FSN Ref: 2025-FSN-000103

Date: 2025-07-03

URGENT Field Safety Notice
Risk of Automated Impella Controller (AIC) Intermittent Impella
Detection Issue.

Image 1: AIC Screen during console-to-console transfer

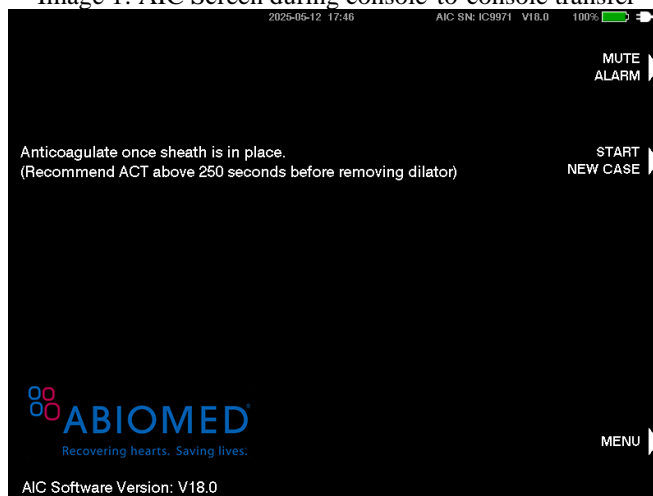
During console-to-console transfer, if the pump is not detected once connected to the AIC, the AIC screen in Image 1 remains and does not advance.

The AIC screen in Image 1 remains for more than 20 seconds and does not advance after connecting the pump to the receiving console:

- Scenario 1: If no alarm on the previous console, then immediately switch the pump to the previous console to restore support to the patient.
- Scenario 2: If the previous console displays an alarm message, then switch to a different console if available. If a different console is not available proceed to scenario 3.
- Scenario 3: If the previous console displays an alarm message, but a different console is not available, then re-start the case on the receiving console (console that does not advance from Image 1 before attempting to re-connect a pump):
 1. unplug the pump
 2. re-start the console
 3. press START NEW CASE from the startup screen

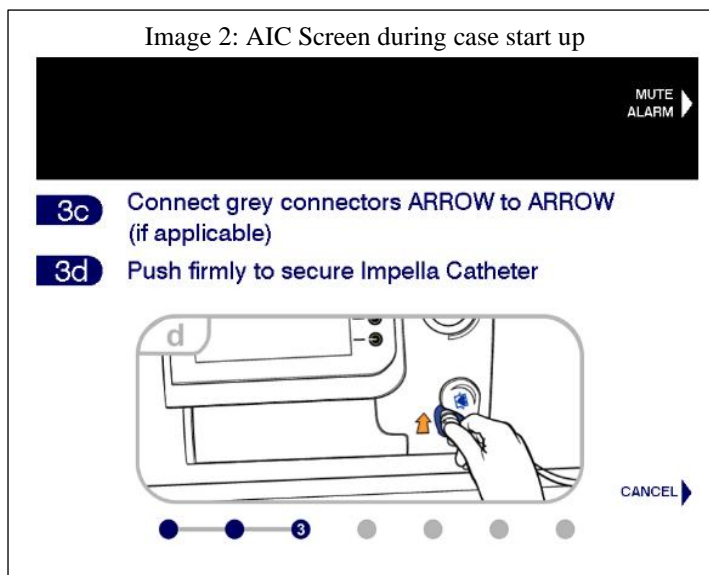
During case start, if the pump is not detected once connected to the AIC, the AIC screen in Image 2 remains and does not advance.

The AIC screen in Image 2 remains for more than 20 seconds after connecting the pump and does not progress to indicate “Detecting Impella”:

- Option 1: re-start the case:
 - unplug the pump
 - re-start the console
 - press START NEW CASE from the startup screen
- Option 2: switch the pump to a different console if available.
